1. Spacerring with 1.25mm thickness

Attention: This information is for the first and second lot.

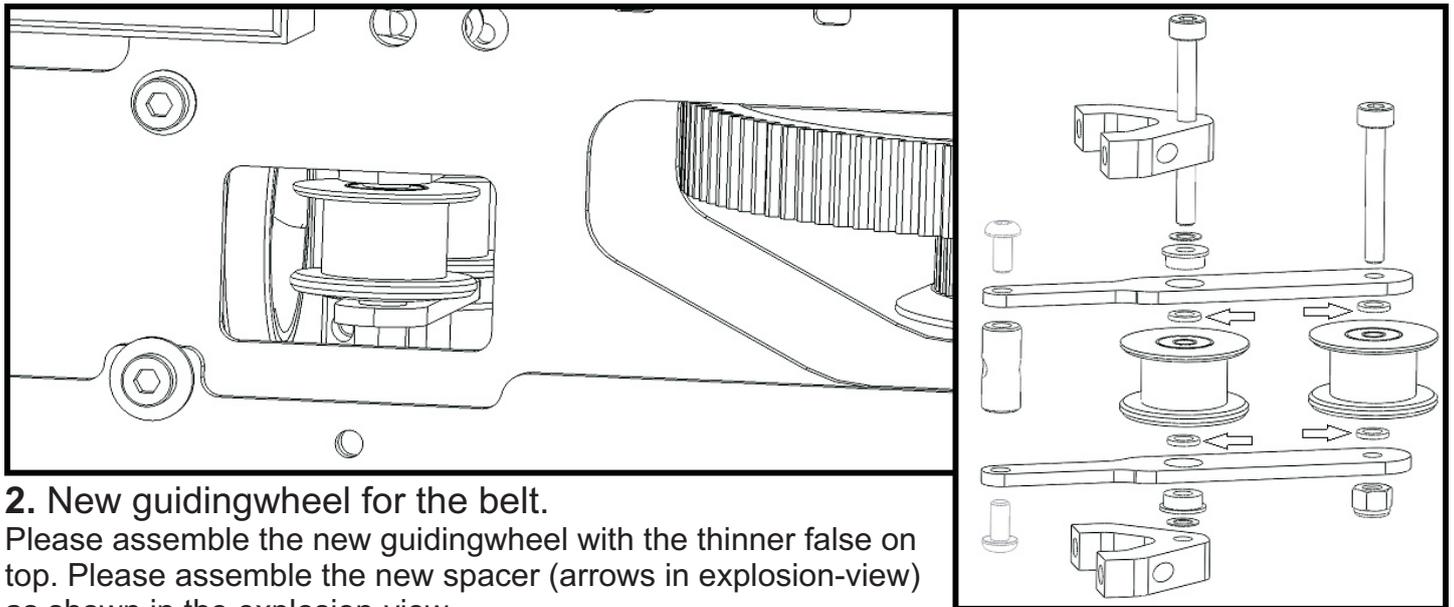
This 1.25mm thick spacer-ring need to be assembled between the oneway-sleeve and the lowestet bearingblock.

2. New guidingwheel for the belt.

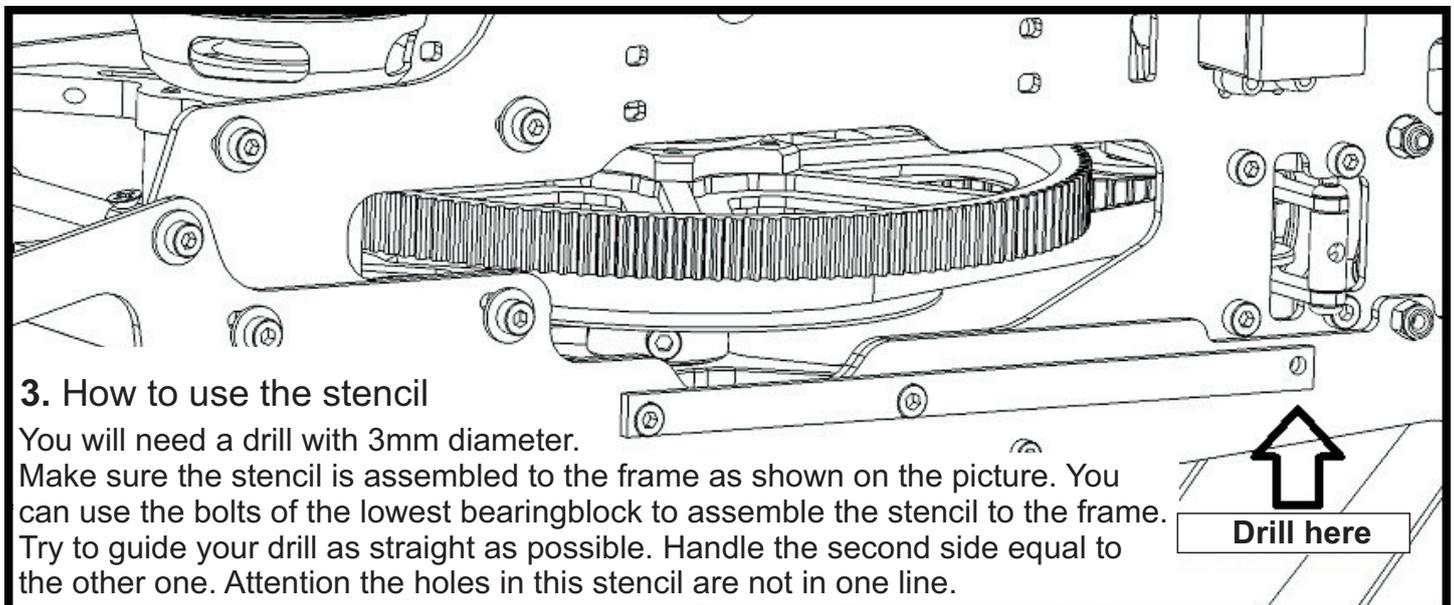
Please assemble the new guidingwheel with the thinner false on top. Please assemble the new spacer (arrows in explosion-view) as shown in the explosion-view.
